Consolidation Coal Company  
Western Region  
2 Inverness Drive East  
Englewood, Colorado 80112  
(303) 770-1600

March 5, 1982

As per our March 5, 1982 conversation concerning the potential prime farmlands acreage within our proposed prep plant permit boundary, I am sending you a letter of explanation and a corrected map which should take care of the problem.

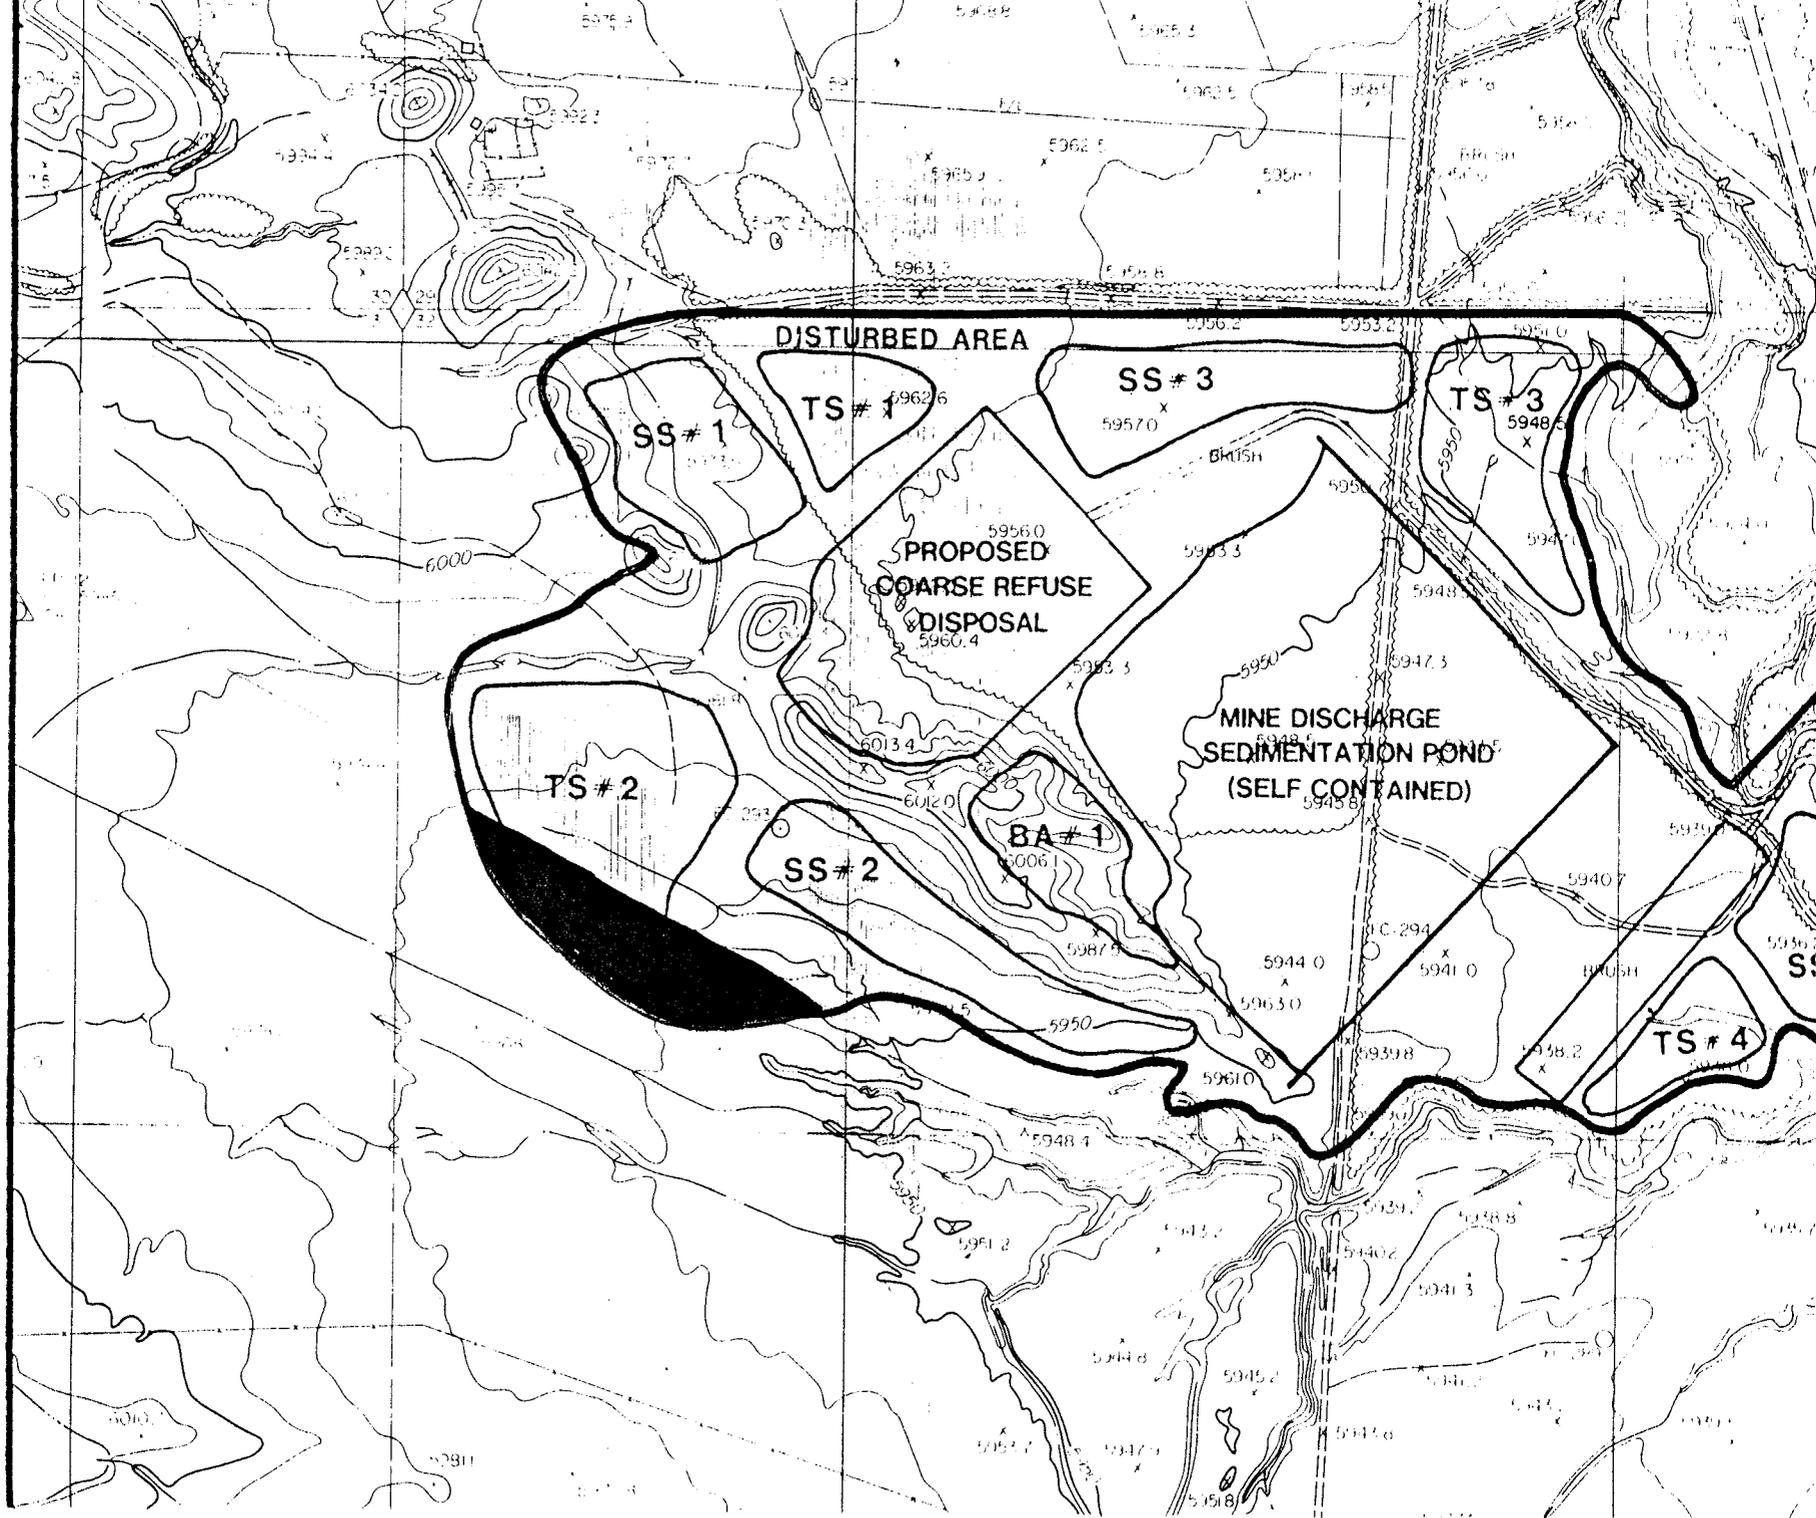
At the time the permit acreage information was sent to your office, we did not realize that this site was a potential Alluvial Valley Floor, or that it was potentially flood irrigated. Therefore, we were not concerned that the acreage could be prime farmland.

The site in question contains approximately 4 acres and is located directly southwest of our proposed coarse refuse disposal area. Please refer to the enclosed map which indicates the location of the acreage which is colored in red. Within the completeness review response, Consol had proposed to stockpile topsoil on approximately half of this acreage, however, this small acreage is not critical to our plan and we therefore choose to omit it entirely. As we discussed in our phone conversation, this would probably be less time consuming as opposed to going through a further prime farmland evaluation. We understand that this acreage correction is to be included within our completeness review and will be treated as such.
